SUBJECT: **DOORS - REPLACEMENT OF CABIN ENTRANCE ASSIST STEPS**

SYNOPSIS OF CHANGE: Changed MATERIAL chart to reflect airplanes without fifth and sixth seat.

EFFECTIVITY: BEECHCRAFT B24R Sierra 200, serials MC-155 and MC-165 through MC-283.

AW-962 O

**Airplanes With Fifth And Sixth Seat
Figure 1**

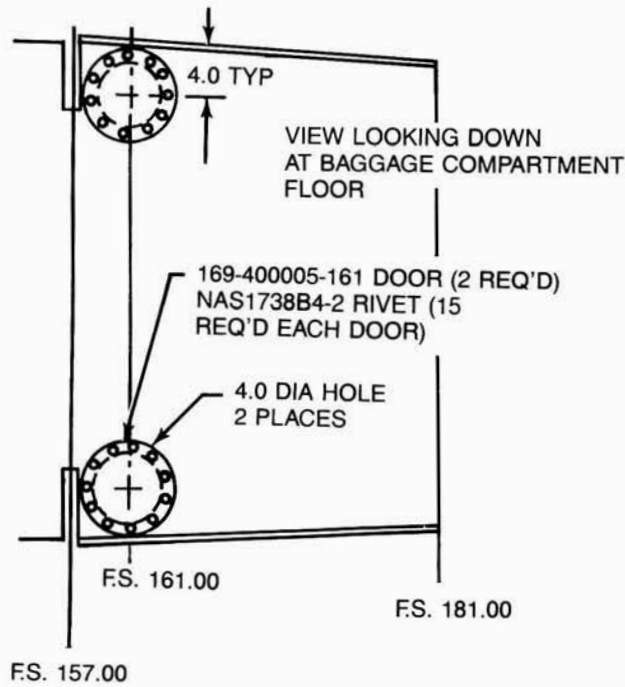
1. Remove the seats and floor carpet as required to obtain access to the area shown in Figure 1 or Figure 2.
2. Cut two 4-inch diameter access holes as indicated in Figure 1 or Figure 2.
3. Remove the two bolts holding the assist step in the adapter tube and remove the step. (See Figure 3.) Access to the nuts on the bolts may be obtained through an existing lightening hole
4. Install the new steps using the existing attaching parts. Torque the bolts to 20-25 inch pounds.
5. Install the two doors over the access holes as shown in Figure 1 or Figure 2. Reinstall the floor carpet and seats and paint the new assist step.

- 169-110000-199 DOOR (2 REQ'D)
- AN525-832-R7 SCREW (8 REQ'D EACH DOOR)
- 130290-1 CLIP NUT ASSY (8 REQ'D EACH DOOR)
